DOCUMENT CHANGE REQUEST

DCR number 488 Changes required for: General

Title: Transistors Low Power NPN, based on type 2N2219A

Number: 5201/003

Metal Can Package (TO-39) - 3 Lead

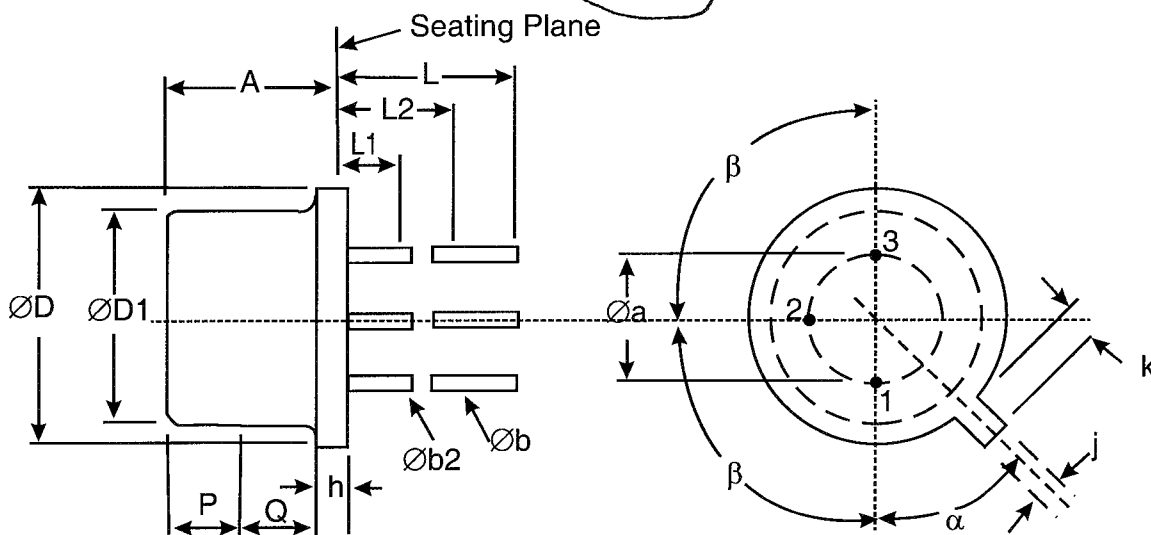
see attached

, and any handling,

no spaces ie (TO-39)
